4230 11th Ave NE
DRB-Recommendation Meeting
February 23, 2015
DPD Project #3017391

Proposal for a new 7 story multi-family building and demolition of existing structures. Current development objectives include:

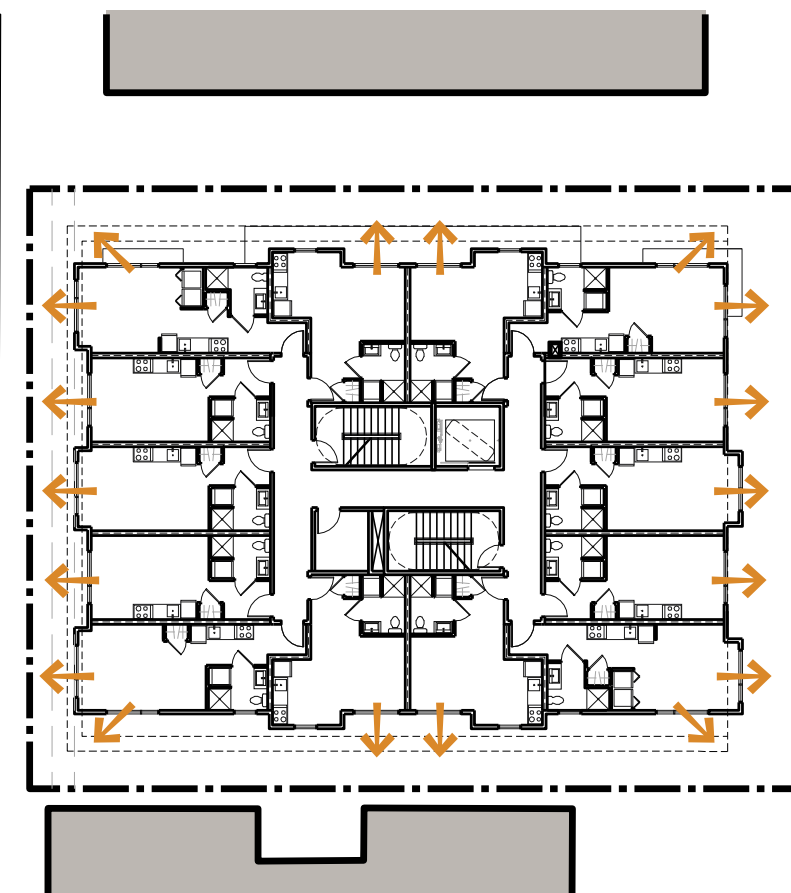
At the next design iteration, detail the relationships between proposed windows on the north and south facades and those on the neighboring buildings. Illustrate corresponding floor heights as well. Look to other structures along the alley to design adequate loading space for the building adjacent the alley.
- > CS2 D-5: Respect for Adjacent Sites

Study how the elements of the front (and rear) facades, can be brought around to the sides of the structure in such a way that it is responsive to neighboring window patterns and expressed concerns regarding privacy for the neighbors.

Most units face the street or alley to avoid the impact of living room windows facing adjacent properties to the North and South. All living room windows are set back 10 ft from adjacent property lines. No building or unit entries are located on the North or South facades. The roof deck has been oriented toward the street and pulled away from the North and South edges of the roof. Landscaping at the ground level deters occupation of spaces between adjacent buildings.
- 2** PRESERVE OR REPLACE EXISTING TREE:

DXU LANDSCAPE GROUNDPLANE PLAN
 SCALE: 1"=10'

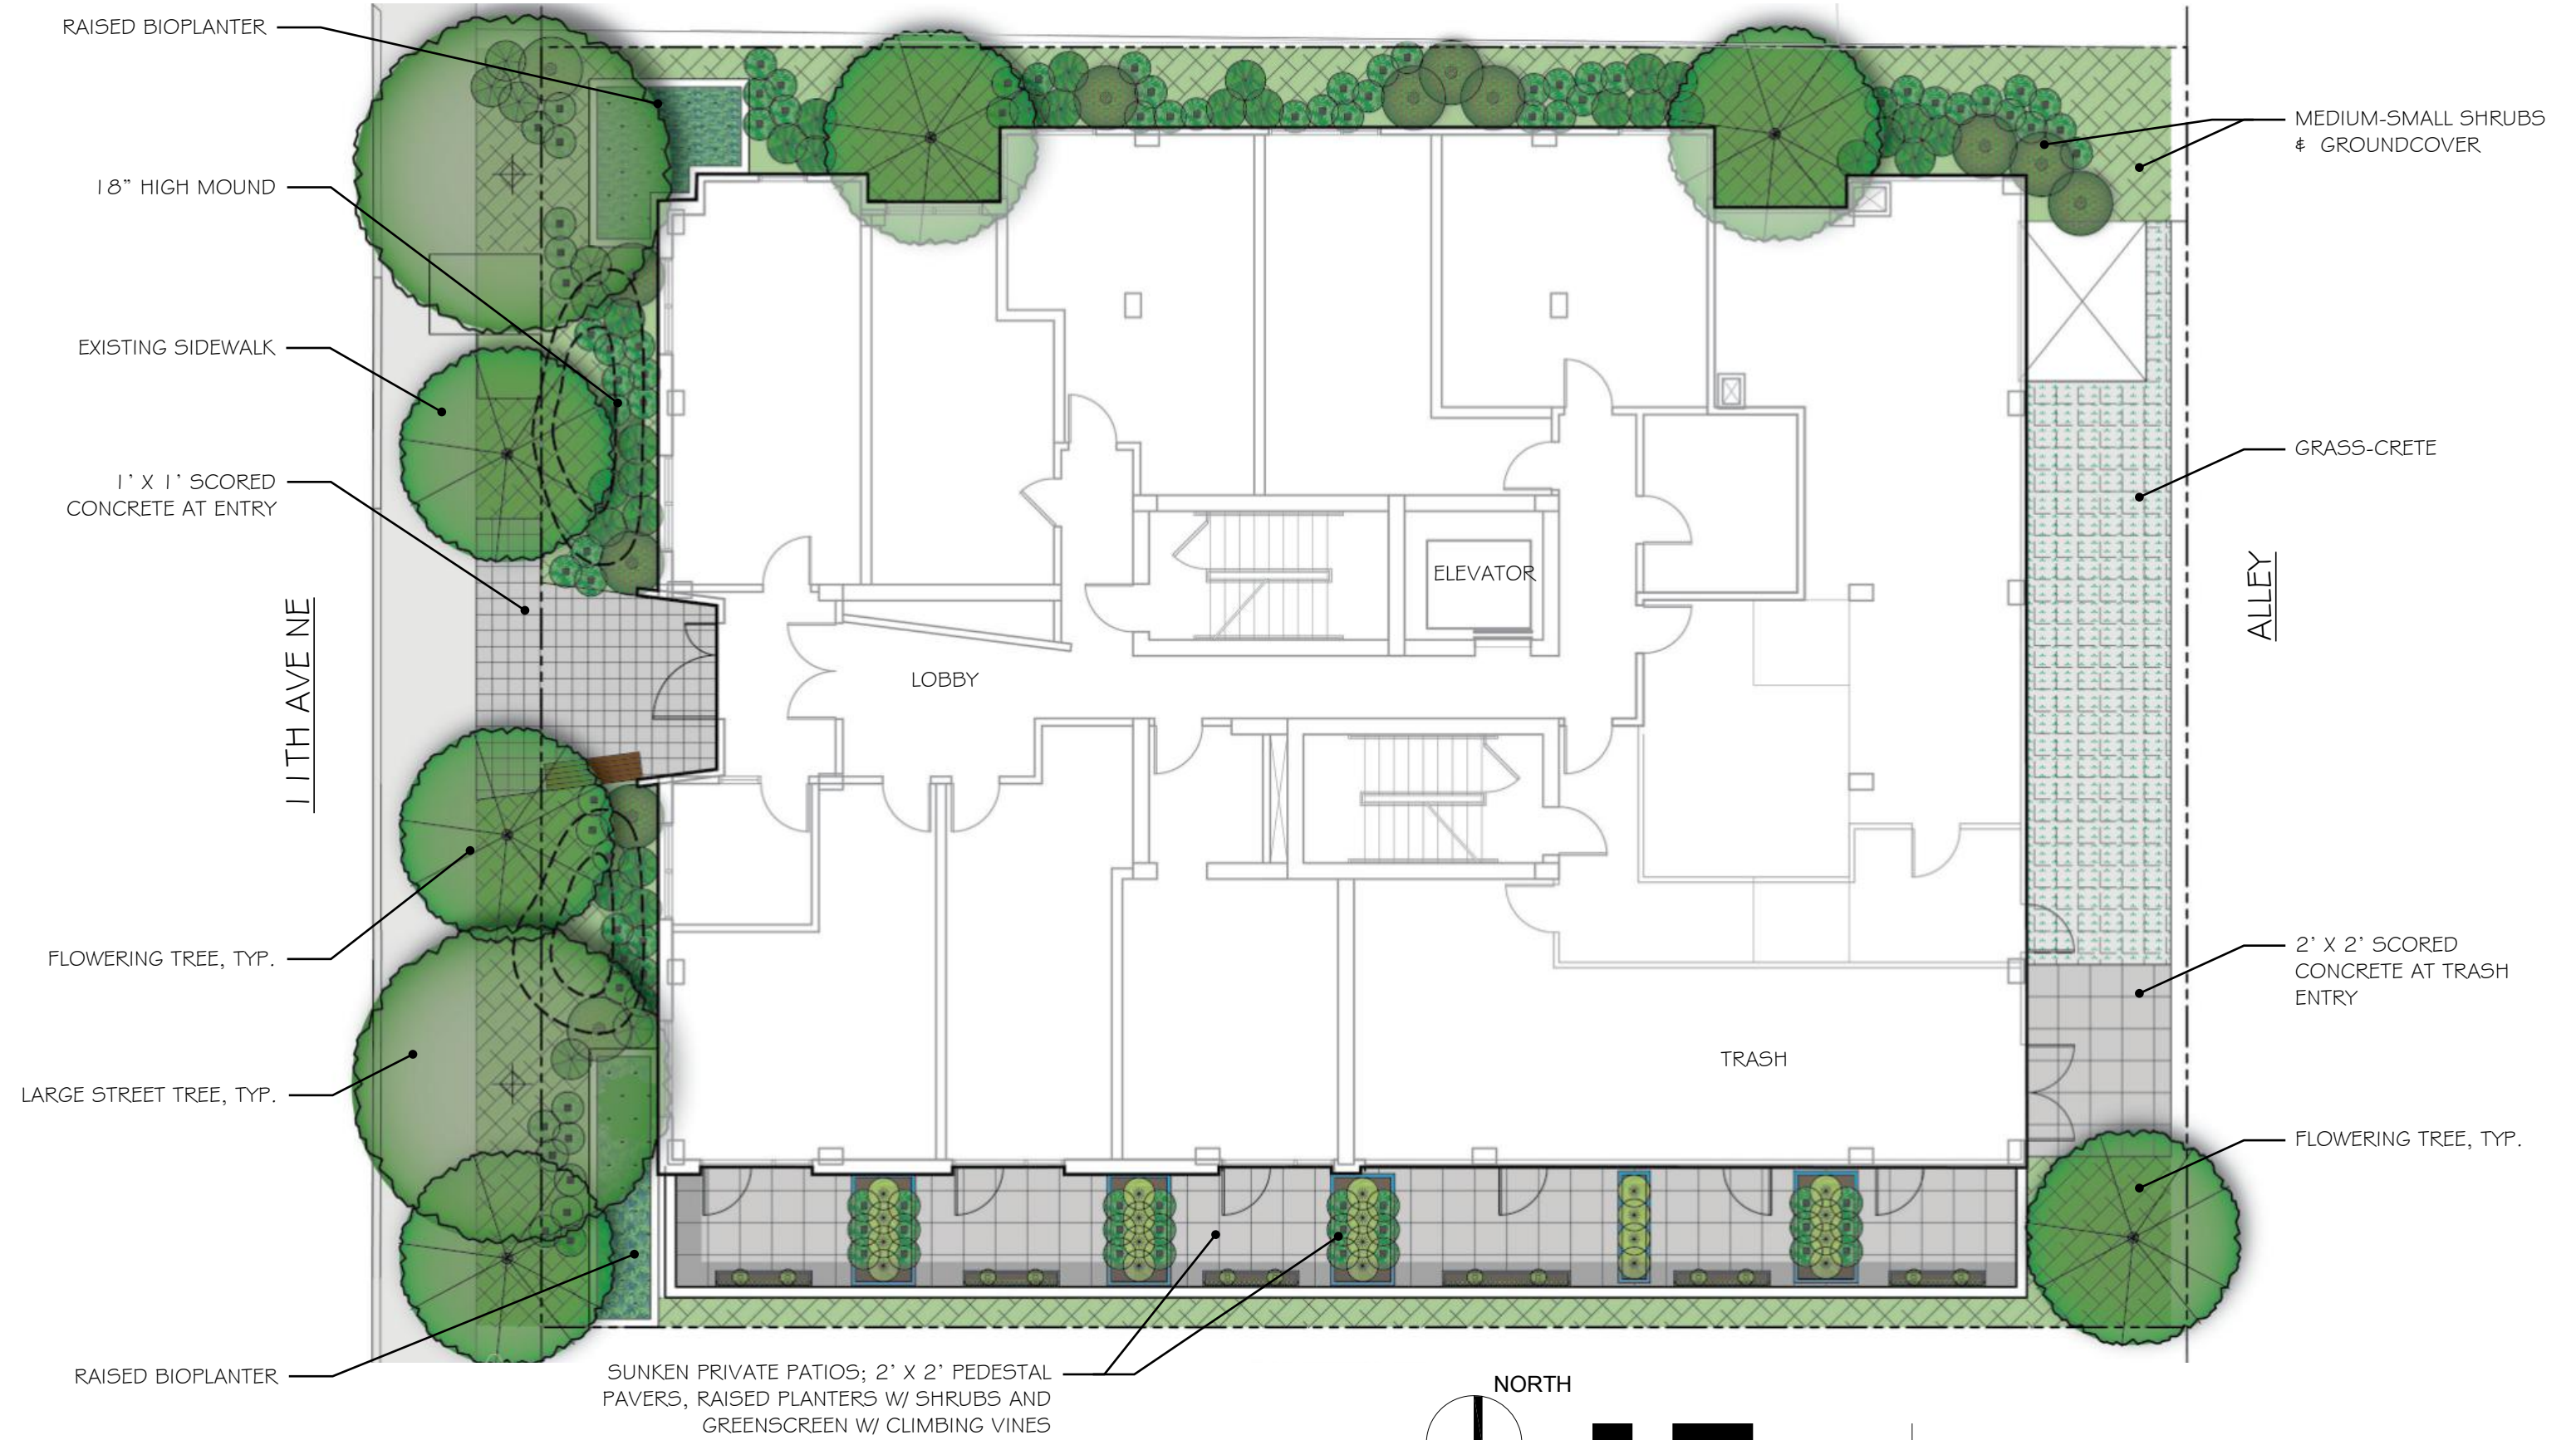
Look into preserving the smaller, cute tree.
- > CS1 E-2: Adding Interest with Project Drainage

In this instance, make a strong effort to retain the smaller tree that shows character and could enhance the overall project.
- > CS2 B-2: Connection to the Street

Explore and report back to the Board regarding the condition and prospects of the "small, cute" tree that was the subject of their solicitude.

According to the Tree Assessment Report, the existing English Walnut tree adjacent to the alley is in poor condition because it is too close to the alley. It will be replaced with a new ornamental feature tree which will be located further from the alley to protect the health of the tree.
- 3** HIGHLIGHT/ORCHESTRATE PEDESTRIAN ENTRIES:
